## Firmware 2.06.3 bug list:

## List of bugs/improvement requests

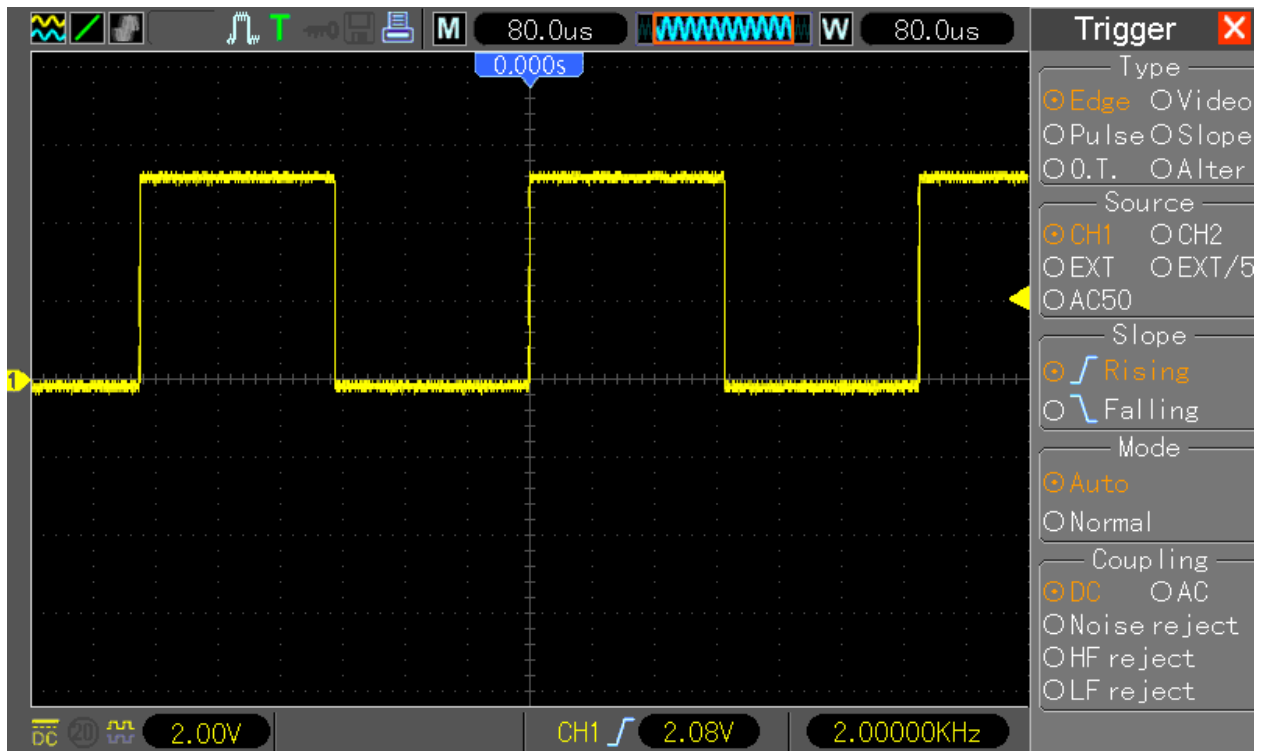
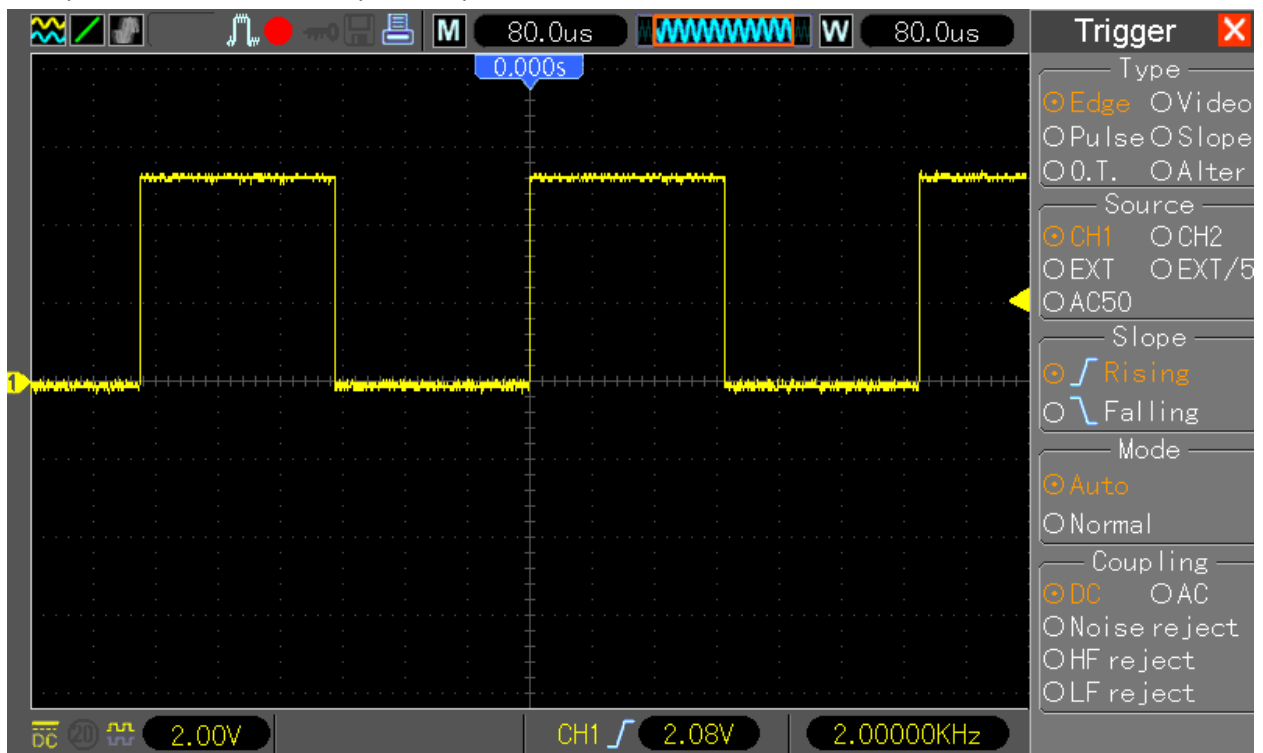
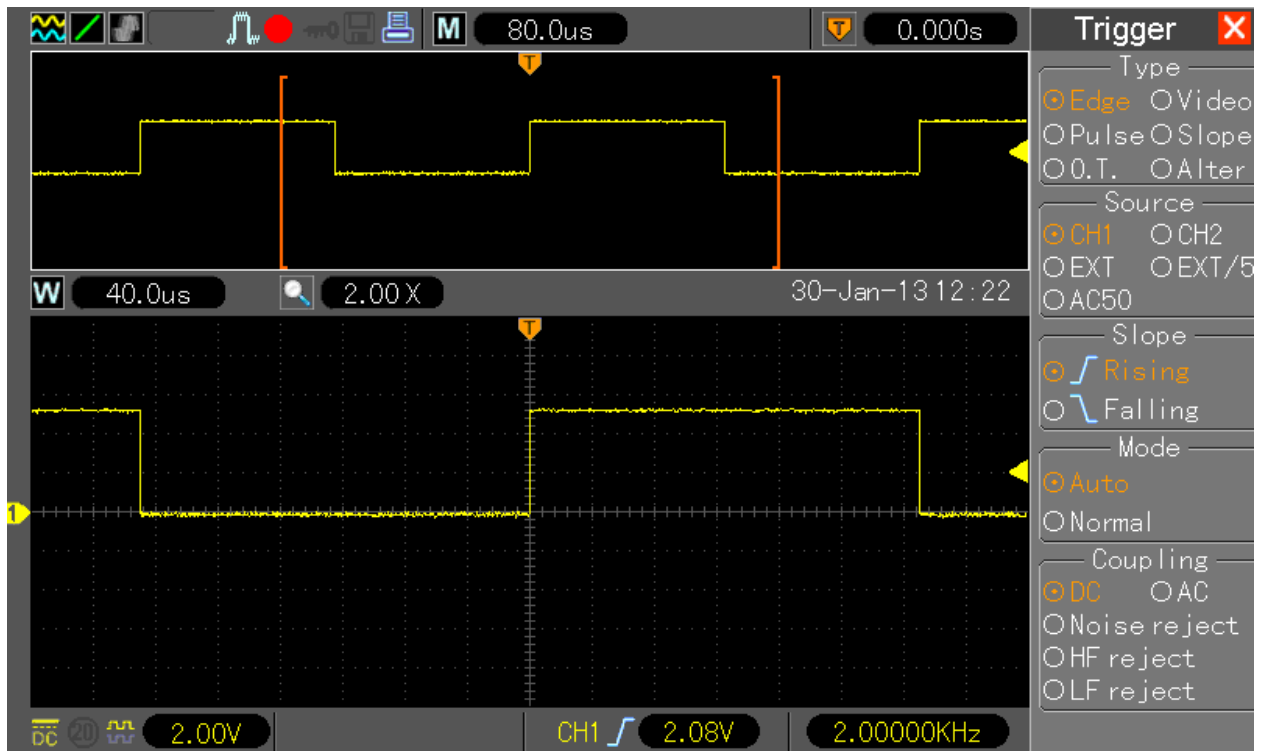
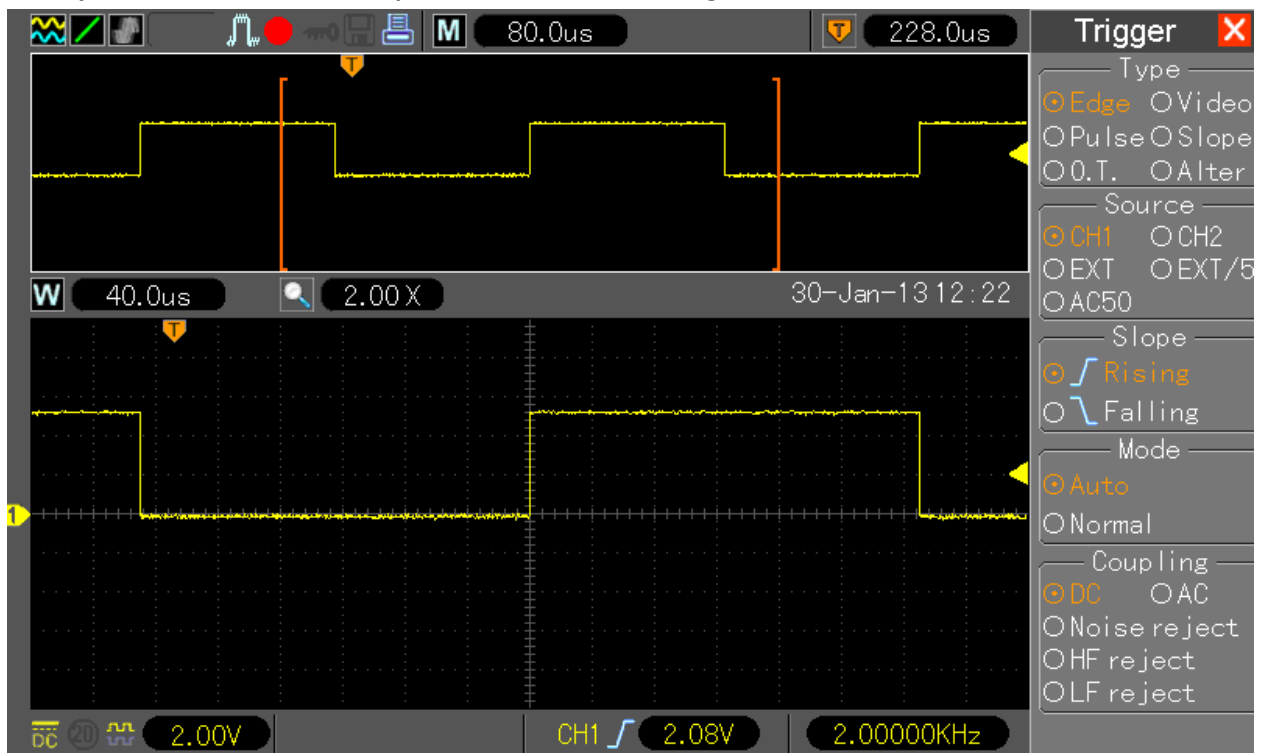
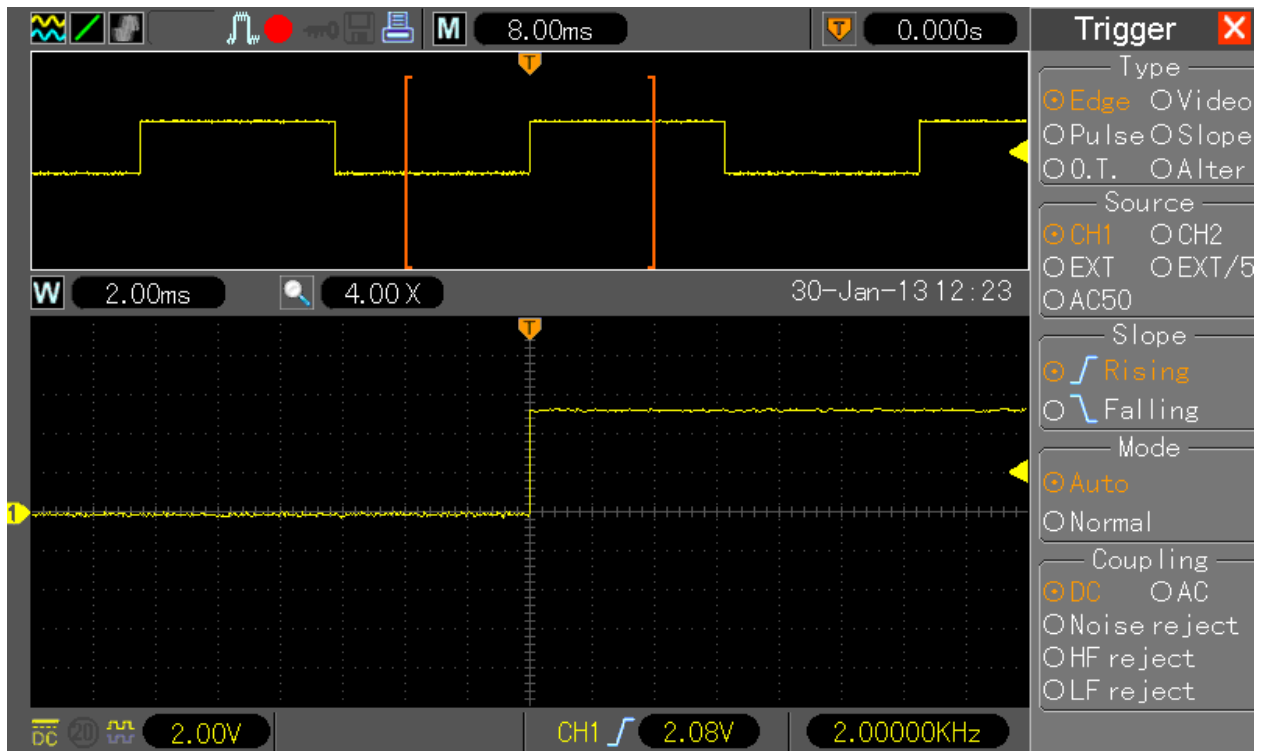
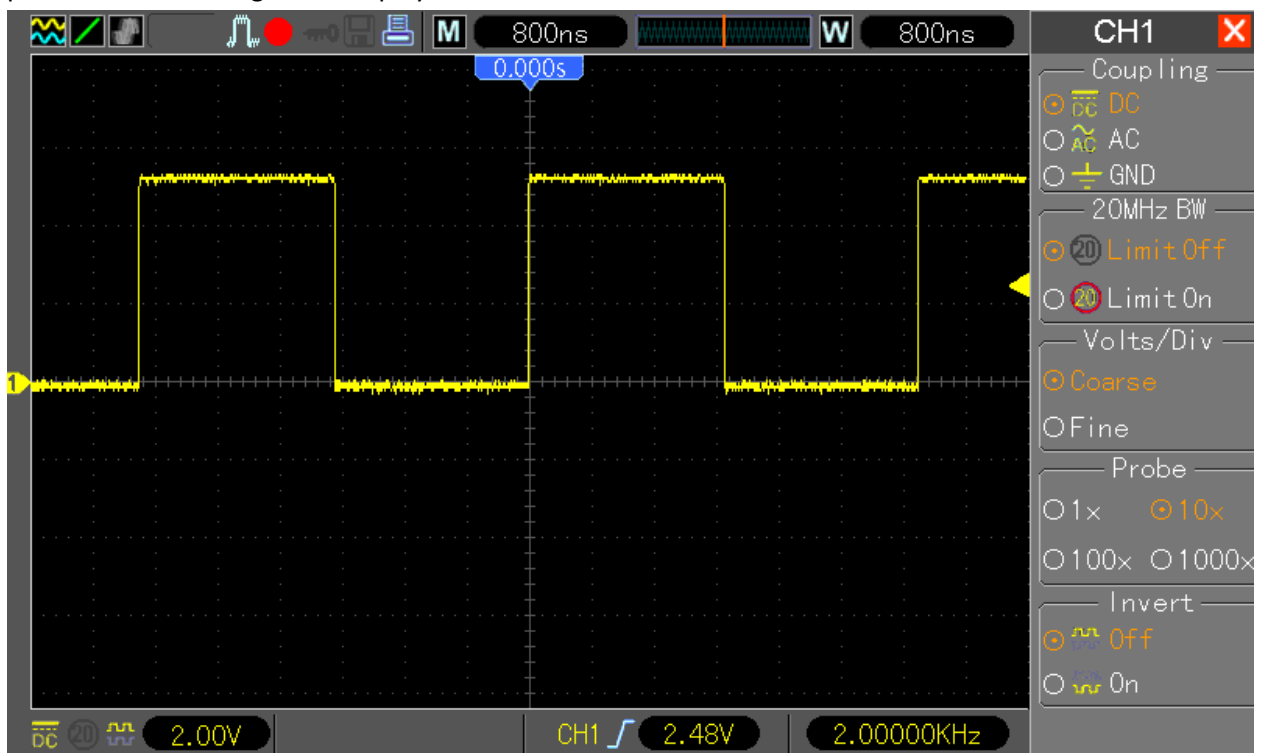
41. **This bug was already there in 2011, then it has been fixed. Now it's again there. This is one of the DSO basic functions; this bug is really annoying and need to be fixed FIRST.**  
 Apply any test signal, push "STOP" button to stop the Acquisition, e.g.:  
 now change to Dual Window by pushing F7, the Waveform disappeared from the Screen!!!:  
**UPDATED: In fw 130130, the waveform is not disappearing from window anymore, but is not usable at all, it can not be moved or zoomed, because it does not change on screen).**  
**UPDATED: In fw 130131, the waveform is not disappearing from window anymore; it can be moved and/or zoomed as well. However two small issues still there:**

The DSO should display 2.5 periods of the waveform:

now push "RUN/STOP" to stop the acquisition:

and push F7 to switch into dual window, the waveform seems to be, top window displaying properly 2.5 periods:

but try now to move horizontal position: wave not moving:

or try to change in MTB window (top window) the timebase, look on my picture, already 8ms/DIV but still only 2.5 periods displayed, so nothing refreshed on display:

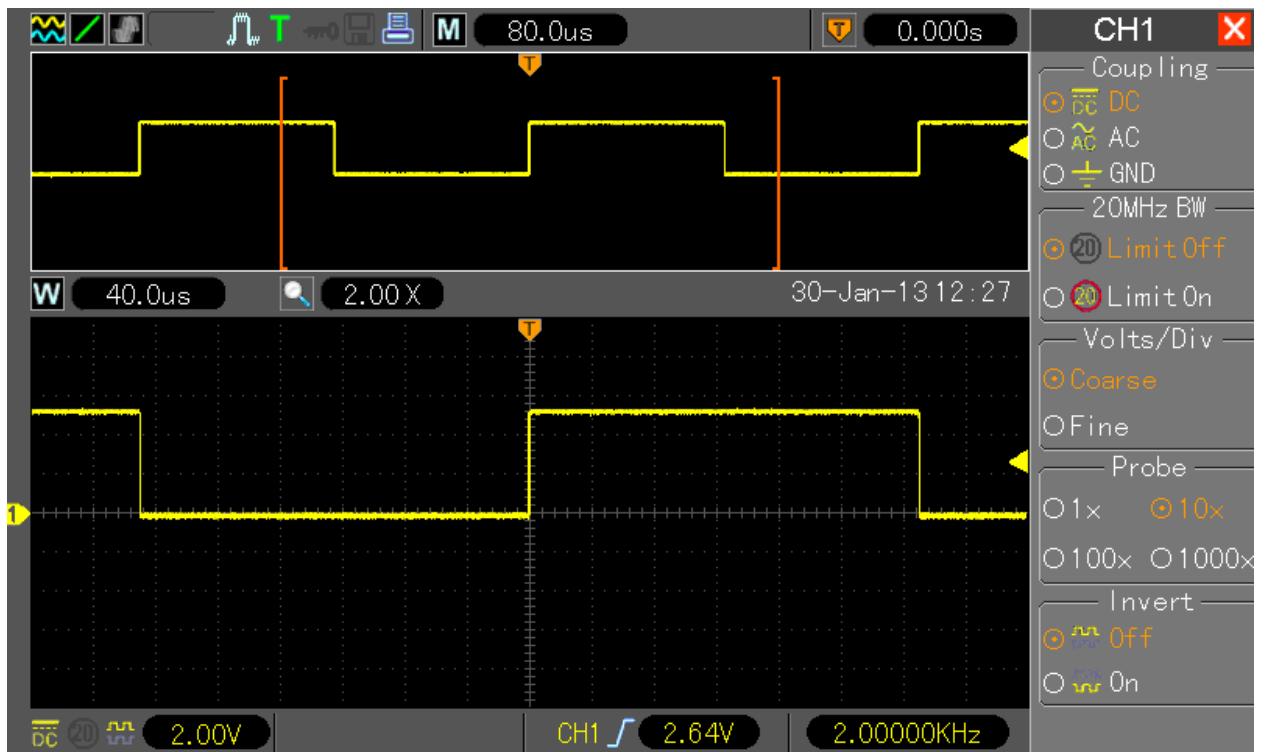
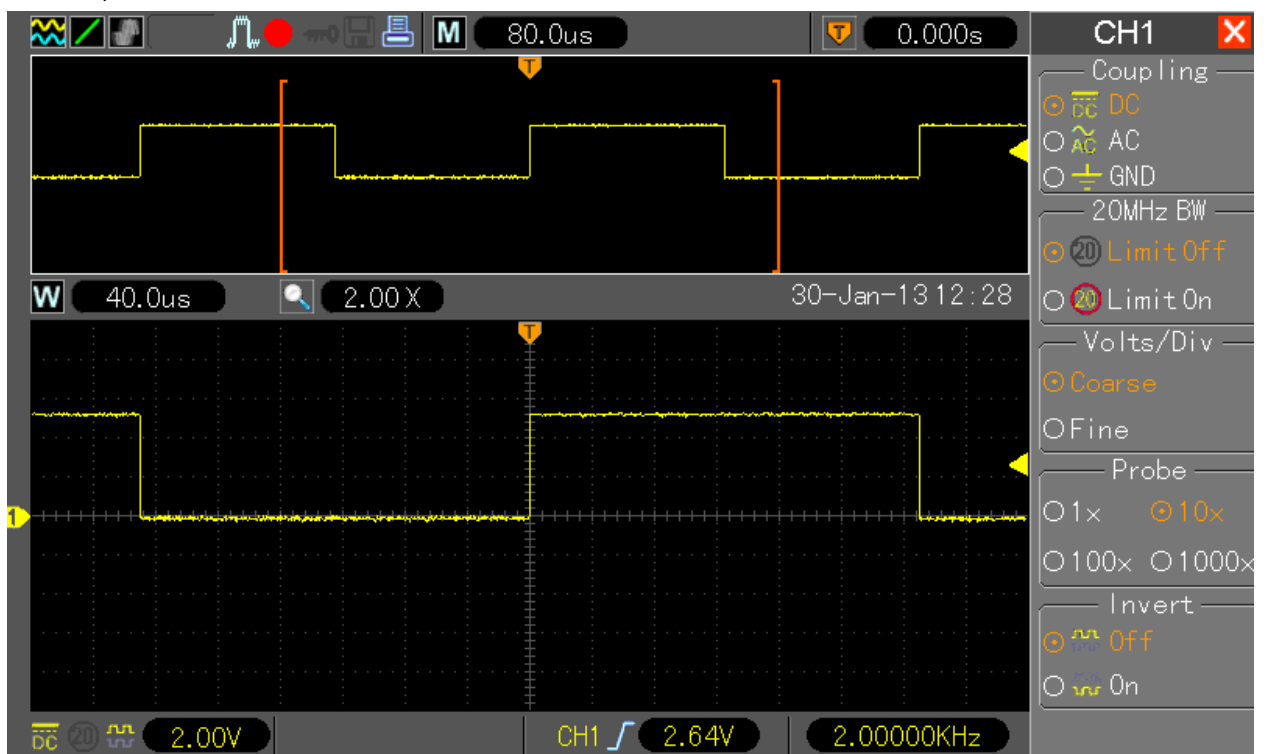
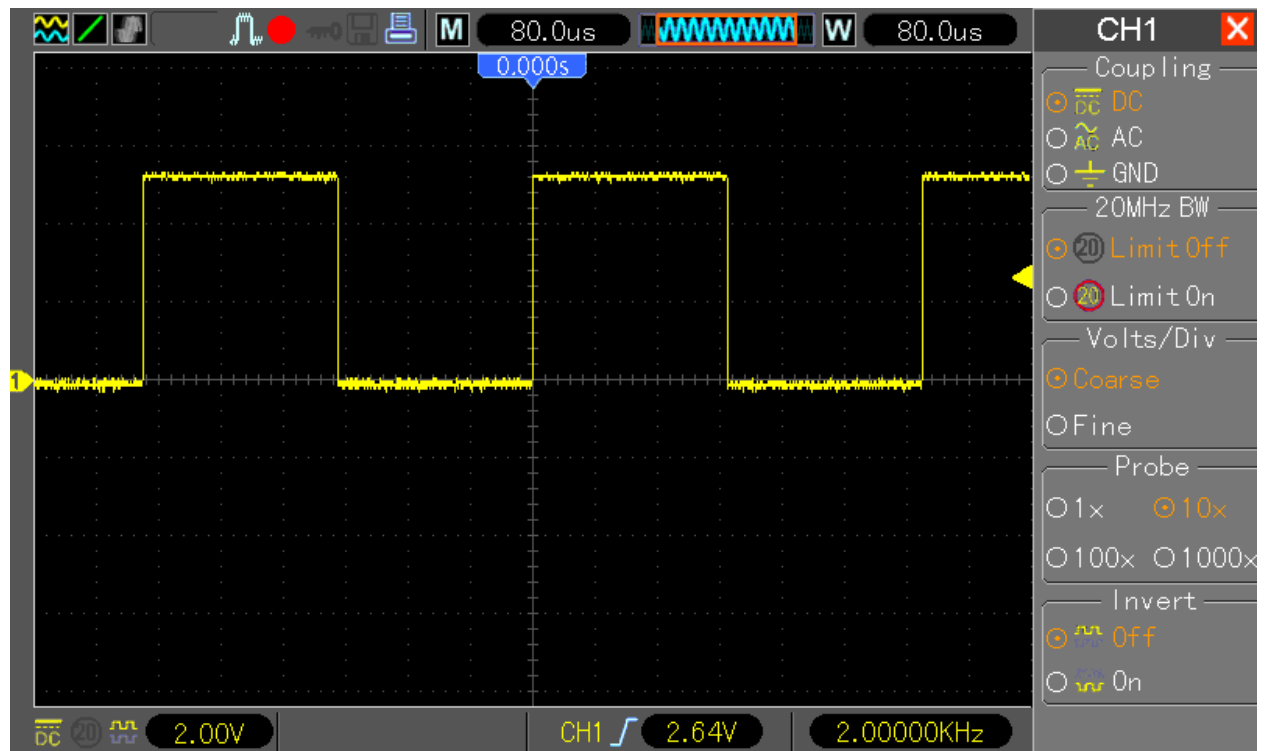
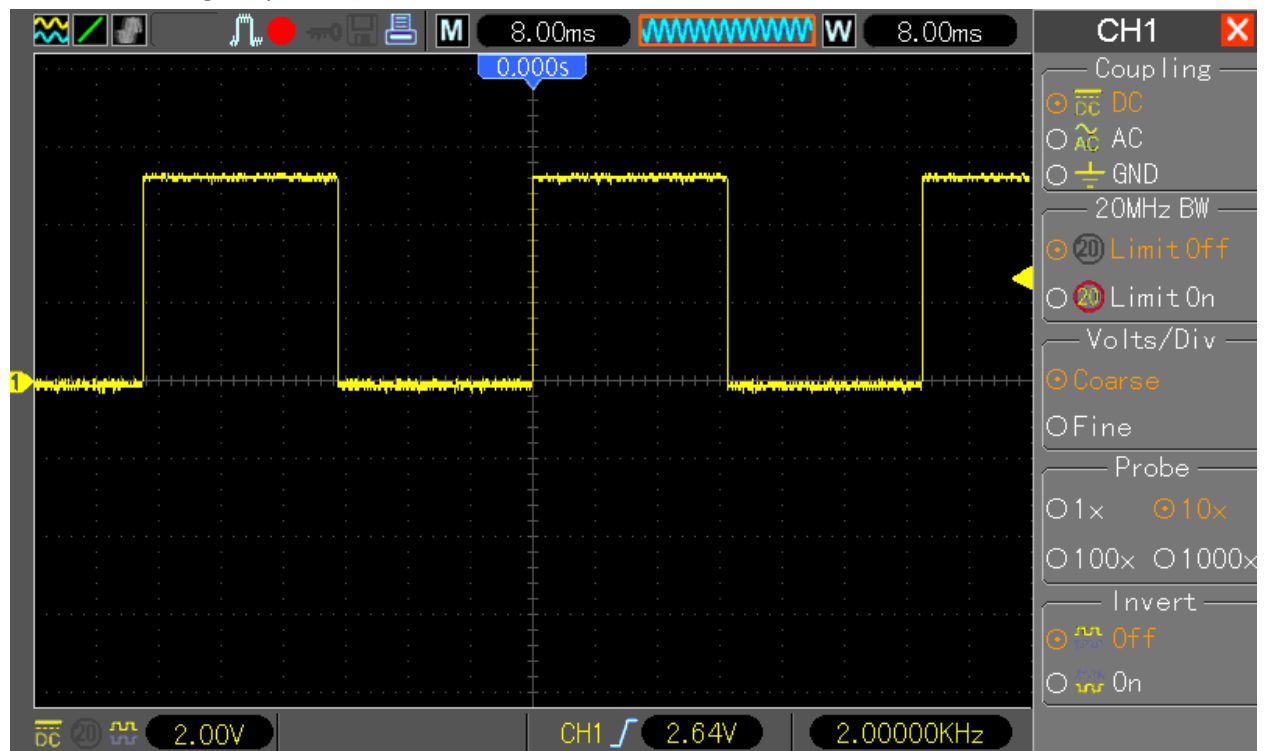
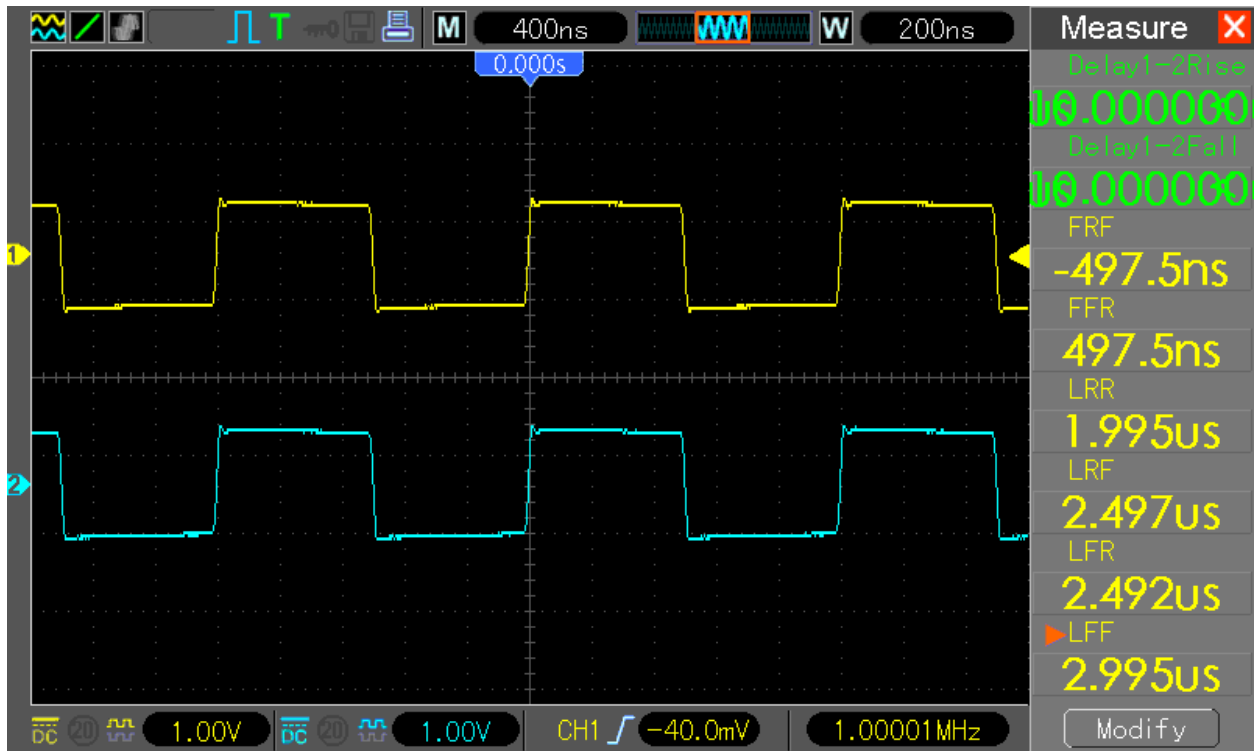
Second example:

Set DSO to 1ch, 4k memory depth, signal generator to 2kHz square, timebase to 80ns/DIV, dual window mode enabled:

now push "RUN/STOP" button to stop acquisition, the waveform is still ok, can be moved or zoomed, etc:

push now F7 to switch to single window mode, the waveform seems to look ok:

but when you try to move it, or turn timebase nothing changing (see my picture, 8ms/DIV but DSO still showing 2.5 periods):
